**AGENDA**  
**PLANNING AND ZONING COMMISSION MEETING**  
**CITY OF CREVE COEUR, MISSOURI**  
**MONDAY, DECEMBER 18, 2017**  
**6:30 PM**

**APPLICATION TO PLANNING AND ZONING COMMISSION  
#16-031 FOR THE REZONING, CONDITIONAL USE PERMIT, AND SITE  
DEVELOPMENT PLAN AND BOUNDARY ADJUSTMENT APPROVAL OF A  
MOBIL ON THE RUN CONVENIENCE STORE WITH GAS PUMPS AND  
BRITWORX CAR WASH FACILITY LOCATED AT 11109-11141 OLIVE  
BOULEVARD & 11100-11114 OAK LAKE COURT, CURRENTLY ZONED GC  
GENERAL COMMERCIAL AND C SINGLE FAMILY RESIDENTIAL**

**REPORT PREPARED BY:** Jason Jaggi, AICP, Director of Community Development; Whitney Kelly, AICP, City Planner  
**DATE:** 12/1/2017  
**ATTACHMENTS:** Applicant's Revised Materials received November 27, 2017  
Draft Ordinance  
Public Comments received

**EXTERIOR  
ELEVATIONS**

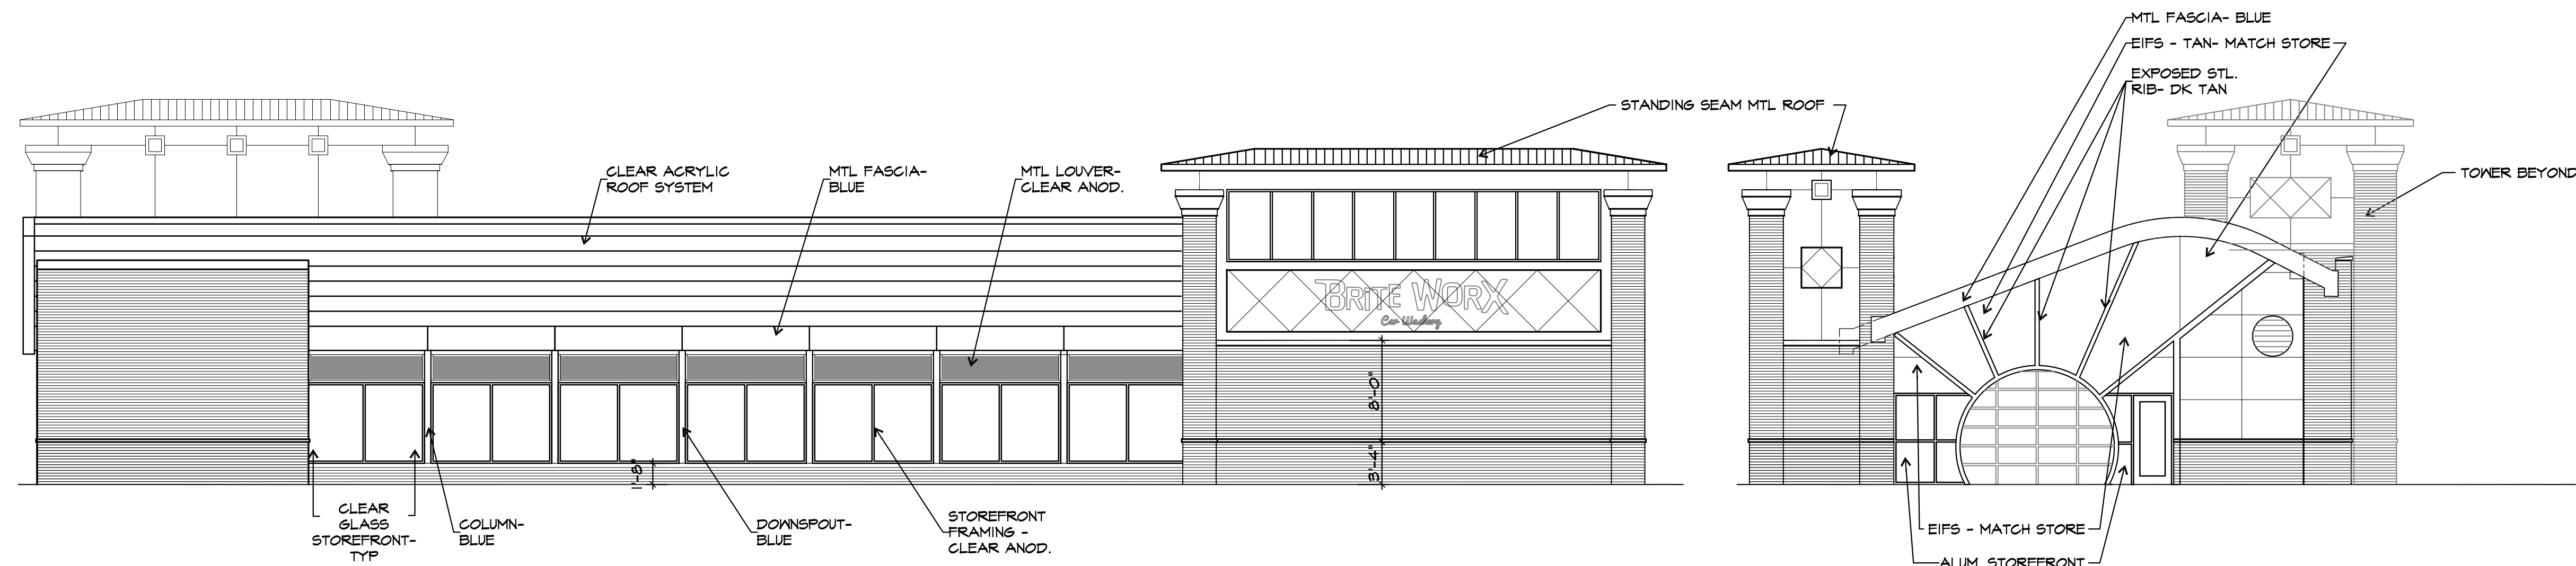
Figure 11: Close-up of the East Elevation showing the height of the storefront in comparison to the overall structure.

**SOUTH ELEVATION**  
SCALE: 1/8" = 1'-0"

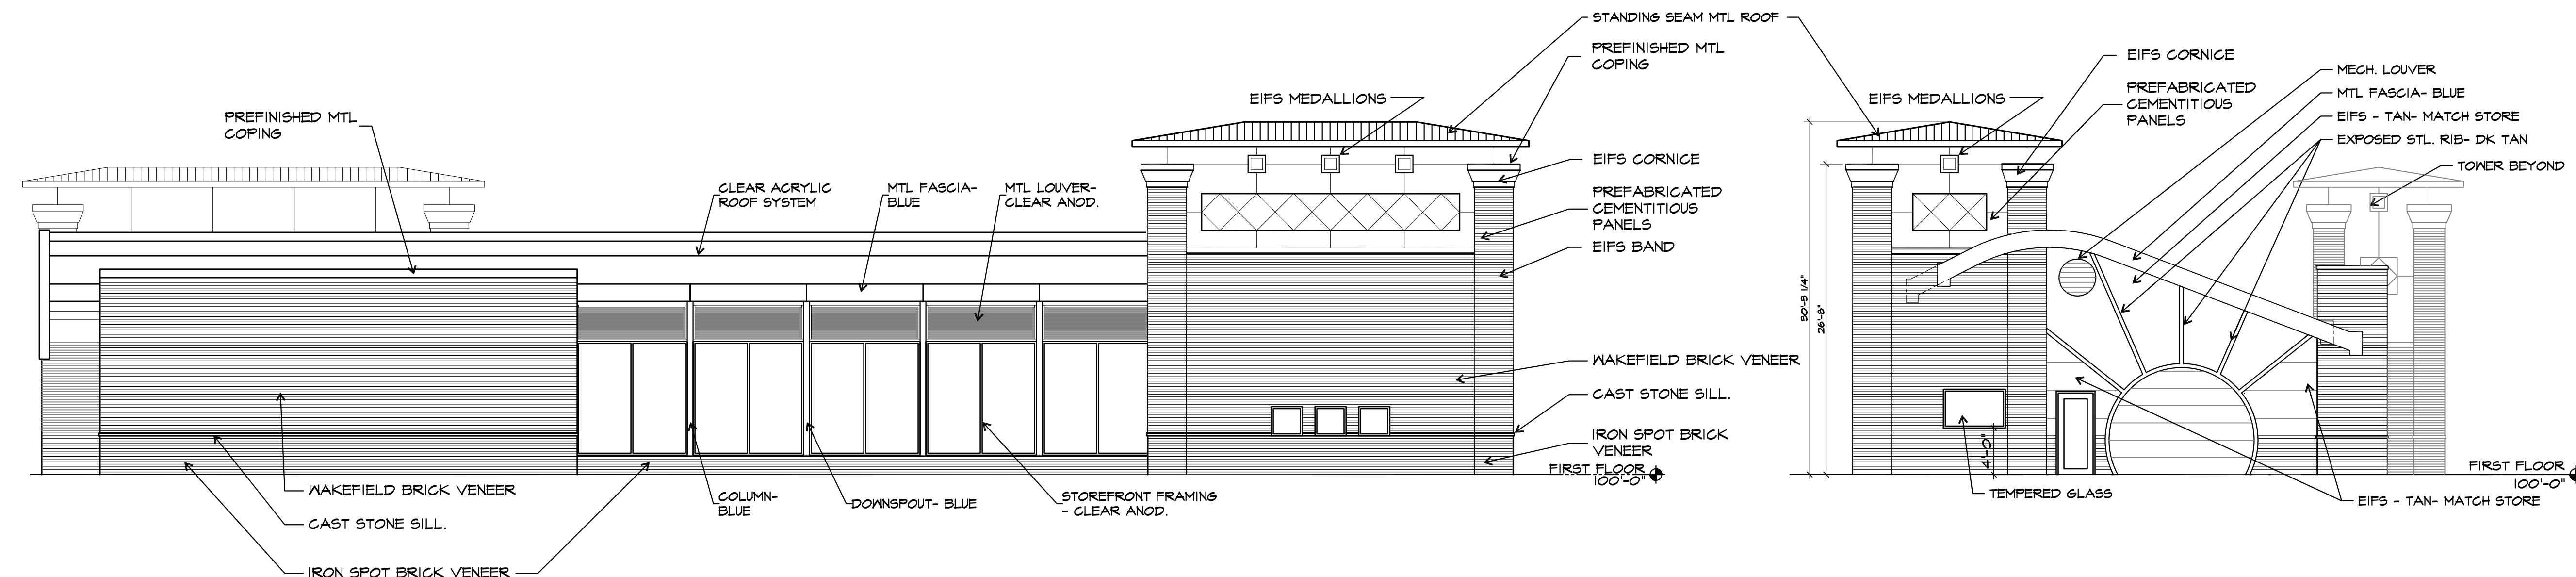
- *Building elements, such as parapet wall, penthouses or screen walls should be treated as an integral part of the architecture.* The mechanical screening and parapet walls are well integrated on the c-store, however, as noted, the amount of brick could be expanded to provide an improved appearance.

- The entrance to the c-store provides for the prominent entrance to attract attention from Olive Boulevard. The doors; however, do not correspond to this element. The applicant has stated that two entrances are preferred to provide easier access to the store. Additionally, the column elements at the front entry do not carry all the way down. Staff would note that the awnings provide covering of the entrances; however, the placement on opposite sides of the tower element are not typical.
